Product Change Notification - KSRA-16NLUE680

CCB 3863 Final Notice: Implement Microchip marking changes for selected Microsemi (PoE, PM and SNR) products

PART MARKING GUIDELINE (Supplement to PCN# KSRA-16NLUE680)

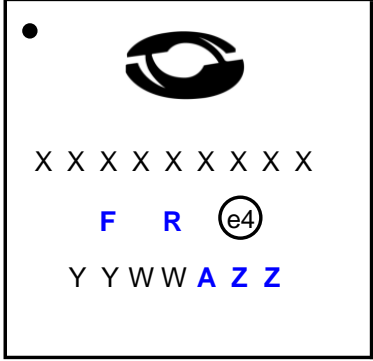
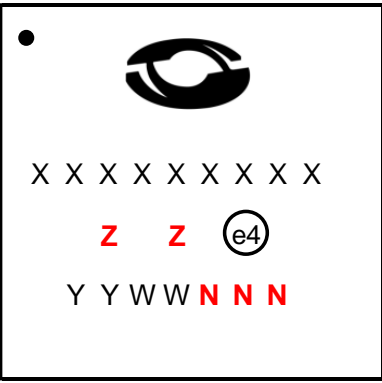
ALL	SOT-143	<p>Front</p> <p>Backside</p>	<p>Top Mark</p> <p>+ = Pin 1 ID XXXX = Part Number YWW = Date Code C = Country Code</p>	<p>Front</p> <p>Backside</p>	<p>Top Mark</p> <p>+ = Pin 1 ID XXXX = Part Number NNN = Traceability Code C = Country Code</p>
